MONTGOMERY COUNTY PLANNING DEPARTMENT

Staff Report: Final Water Quality Plan & Site Plan 820050410 Clarksburg Village Phase II

RECOMMENDATION: Approval with conditions

Newcut Road Neighborhood Land Use Plan

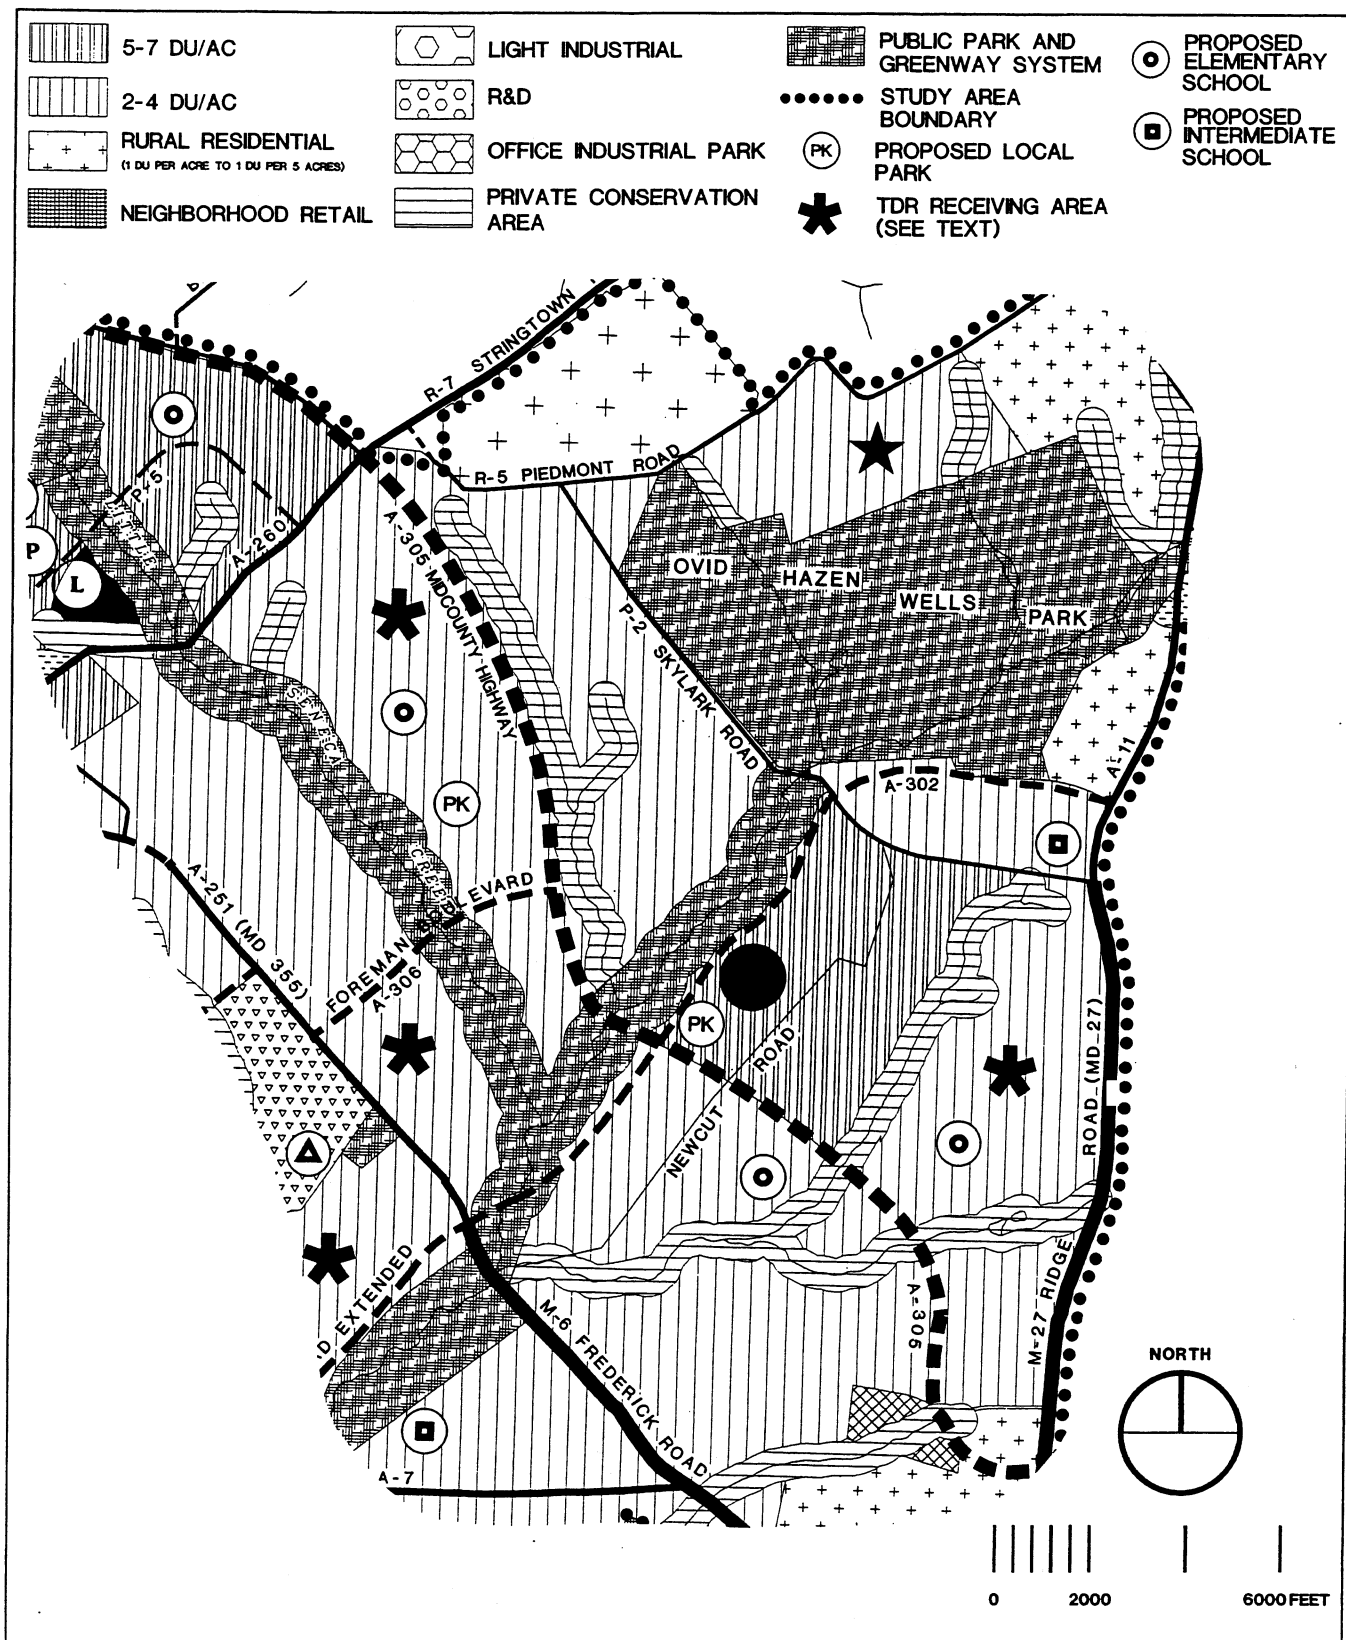
As shown in Figure 1, the land use recommendations for the Newcut Road Neighborhood propose a mixed-use center (Phase III development) on Little Seneca Parkway, approximately midway between Snowden Farm Parkway and Skylark Road. This will provide a concentration of activity and density in the middle of the neighborhood while promoting lower densities at the edges. This concept also clusters development near the greenway system and enhances public access to the 290-acre Ovid Hazen Wells Recreational Park.

Newcut Road Neighborhood Illustrative Sketch

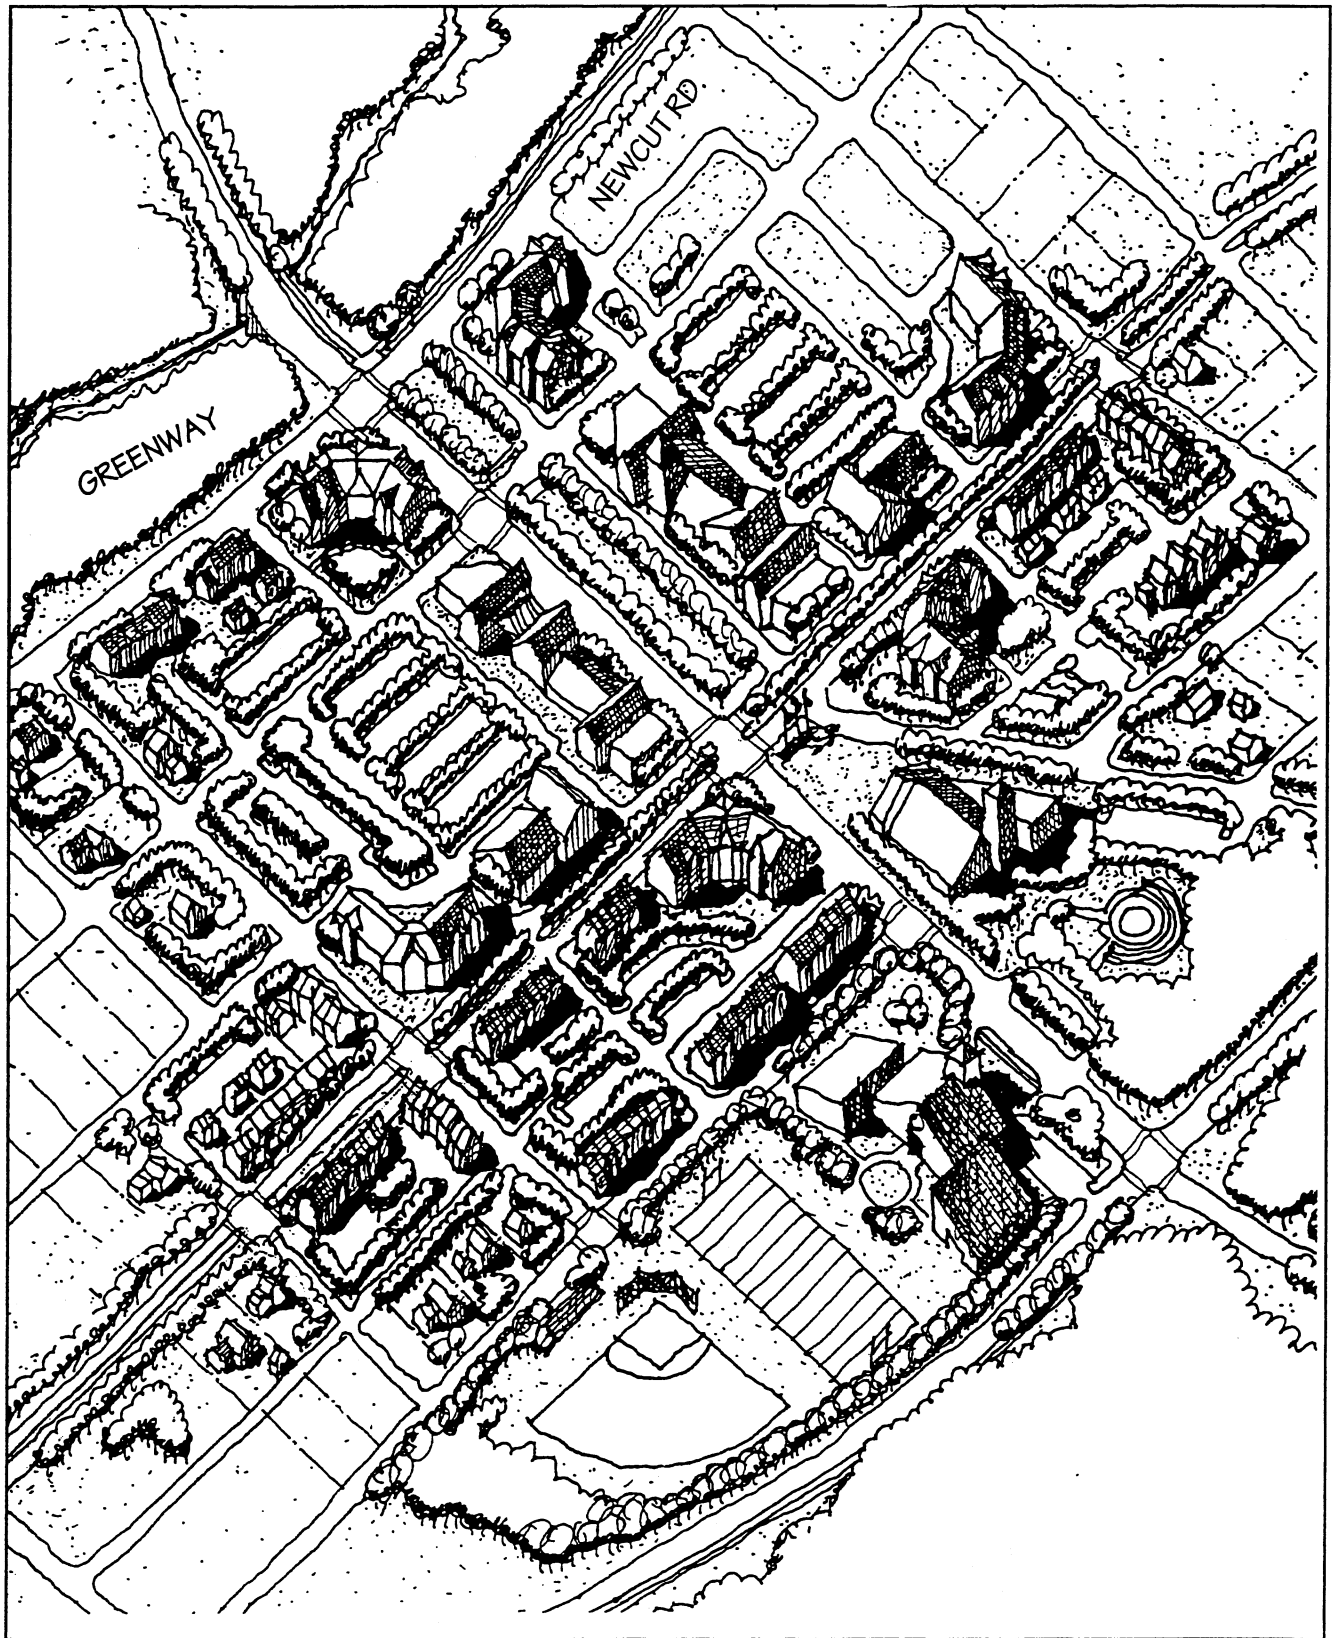
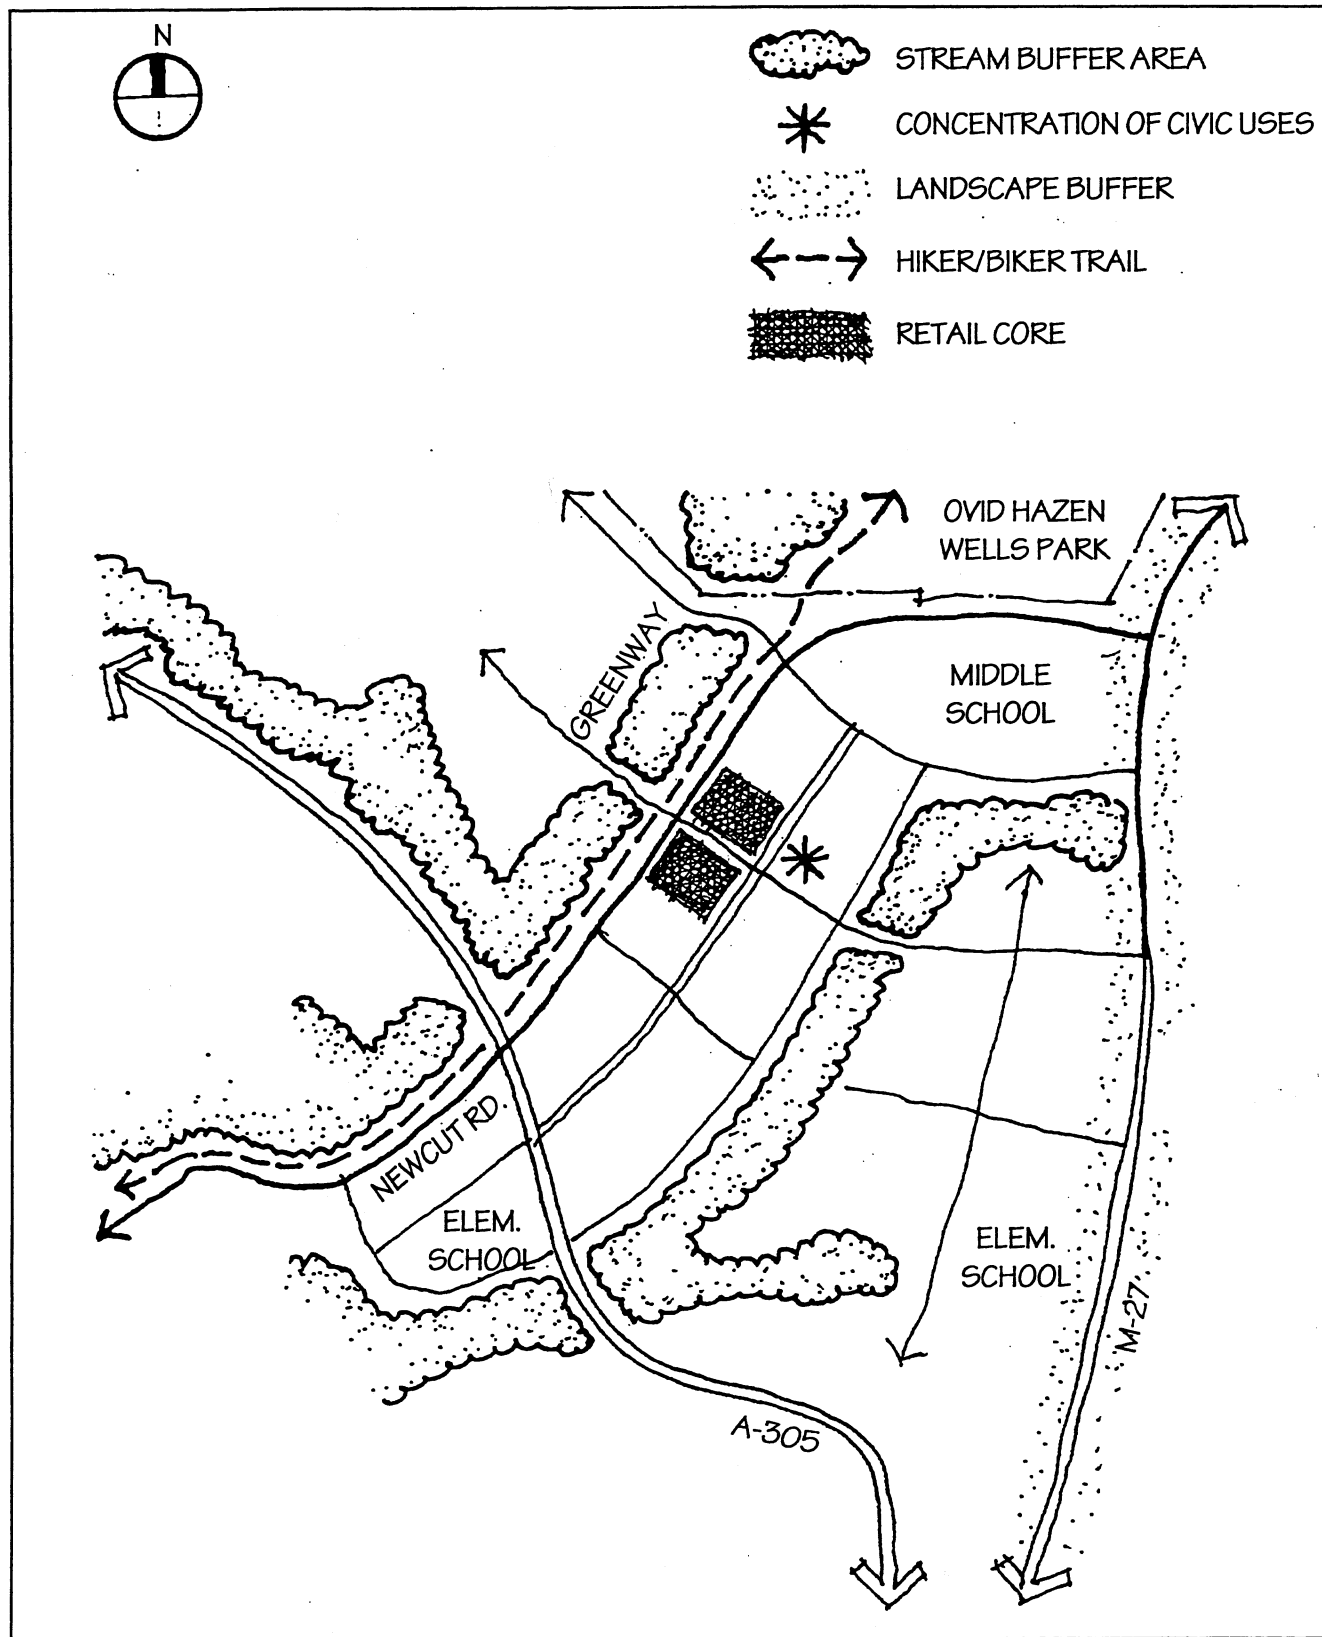
Conformance to the Master Plan's Policy 7, street orientation and specific language in the Newcut Road Neighborhood, page 62, is very important if Clarksburg is to be a neo-traditional community that will make Clarksburg unique and appealing. See Figures 2 and 3.

The Master Plan recommends a landscaped buffer along Ridge Road (MD 27) the entire length of the property as shown in Figure 3.
